## **ROE PROPERTY SUBDIVISION,** **RESUBDIVISION OF LOT 1**

APPLICATION NUMBER 2 DATE July 16, 2020  
 APPLICANT Roe Property Subdivision, Resubdivision of Lot 1  
 REQUEST Subdivision

# DETAIL SITE PLAN

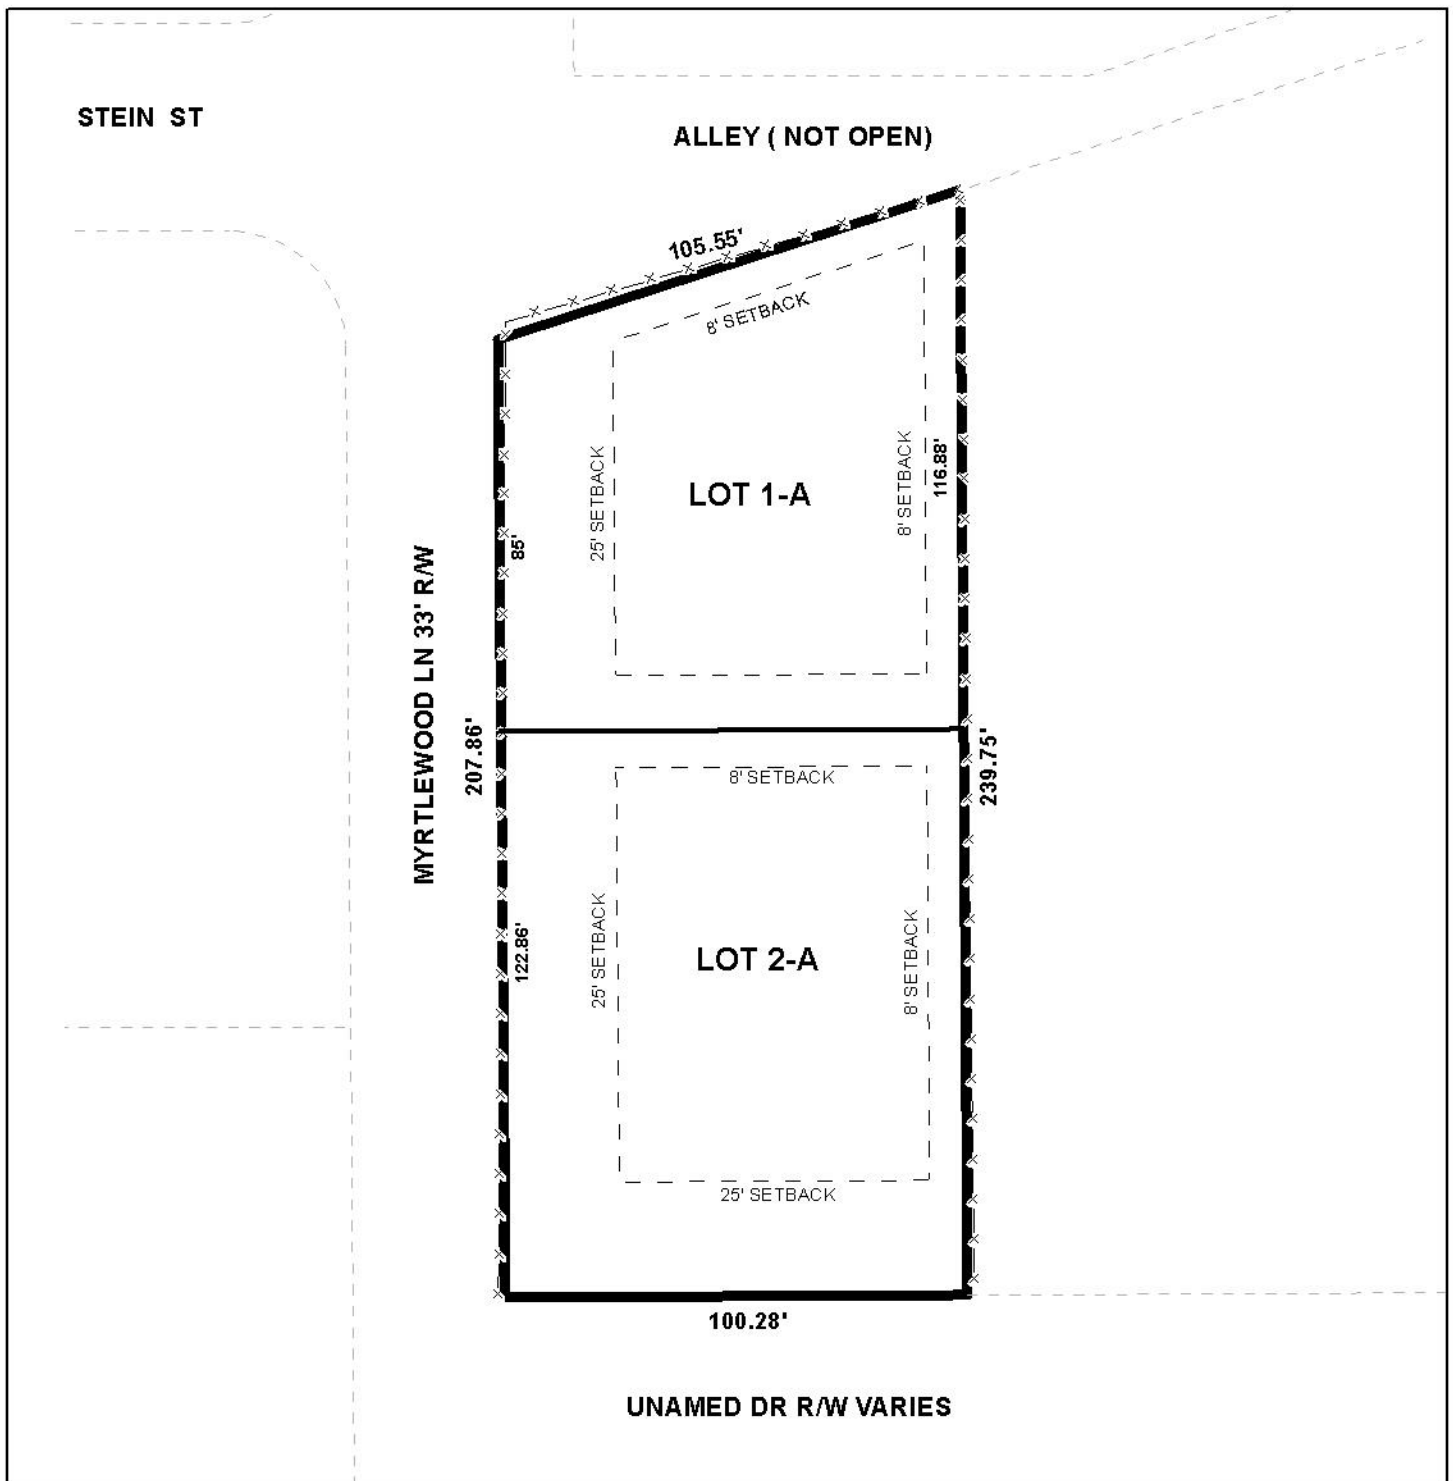
- B. Provide the dimensions of the ROW width for the unnamed ROW on the south side of LOT 2-A.
- C. Show and label the monument set or found at each subdivision corner.

- D. Dedicate the corner radius (25' minimum or as approved by the City Engineer and Traffic Engineer) at the northwest corner of LOT 1-A and southwest corner of LOT 2-A to the City of Mobile, and list the amount of dedicated acreage.

As proposed, both lots have frontage onto Myrtlewood Lane, a minor street with curb and gutter requiring a 50-foot right-of-way width. The preliminary plat illustrates a non-compliant 33-foot right-of-way. As was required in 1980 for the adjacent Sigler Subdivision (also originally a Roe Property Subdivision lot), and in 1988 for Gaillard Oaks, across the street, dedication sufficient to provide 25 feet from the centerline should be required.

Proposed Lot 1-A abuts a public alley (no right-of-way width provided) to the North of the subject property. Historically, this alley provided pedestrian only access between Stein Avenue / Myrtlewood Lane and Avalon Street / Devendel Lane, as a stairway used to exist in the alley due to the change in elevation between the two sets of streets. The applicant has stated a desire to use a portion of the unimproved alley to access a proposed garage, and as such has requested a reduced setback along the alley of 8 feet. The applicant proposes a 12-foot setback on the opposite side, to provide the Zoning Ordinance minimum combined sideyard setbacks. As Section V.D.9. of the Subdivision Regulations only provides for a 25-foot setback from abutting street rights-of-way, this section would have to be waived in order to allow the requested 8 foot setback along the alley. Section V.B.14. of the Subdivision Regulations requires a minimum right-of-way width for alleys of 20 feet, thus the plat should be revised to depict the existing alley width and, if necessary, the dedication of right-of-way to provide the minimum 20-foot width.

Proposed Lot 2-A abuts an unnamed right-of-way to the South, which the applicant intends to be the primary frontage for the lot. It should be noted that for addressing purposes, the lot will likely be given an address number along Myrtlewood, not the unnamed street. Additionally, the unnamed street appears to provide access to the house located at 114 Myrtlewood. The right-of-way of the unnamed street is indicated as varying, however, plat should be revised to either indicate that the unnamed right of way has existing minimum width of 50', or dedication should be required to provide 25' from the centerline. The applicant could consider requesting a waiver of Section V.D.9. of the Subdivision Regulations to allow for the setback along the unnamed right of way to only be 20 feet, as would be allowed by the Zoning Ordinance.

Dedication of corner radii in compliance with Section V.D.6. of the Subdivision Regulations at both the Northwest corner of Lot 1-A and the Southwest corner of Lot 2-A, should be coordinated with the City Engineer and the Traffic Engineer, if determined necessary. In addition, the revision of minimum building setback lines adjusted for dedication will be required.

No easements are indicated on the preliminary plat. If any easements are recorded on the site they should be indicated and labeled on the Final Plat, and a note should be placed on the Final Plat stating that no structure may be placed or constructed within any easement.

- 1) Waiver of Section V.D.9. of the Subdivision Regulations to allow for an 8-foot setback from the alley on the North side of proposed Lot 1-A, and a 20-foot setback from the unnamed right-of-way on the South side of proposed Lot 2-A;

- 2) dedication to provide 25' from the centerline of Myrtlewood Lane;
- 3) either illustration that the alley abutting Lot 1-A has a minimum 20' right-of-way, or dedication to provide 10' from the centerline as necessary;

- 4) coordination with the City Engineer and the Traffic Engineering regarding the provision of a corner radius in compliance with Section V.D.6. of the Subdivision Regulations at both the Northwest corner of Lot 1-A and the Southwest corner of Lot 2-A, if a radius is determined necessary;

- 5) revision of minimum building setbacks, adjusted for dedication;
- 6) retention of the lot size in both square feet and acres, or the furnishing of a table on the Final Plat providing the same information, adjusted for dedication;
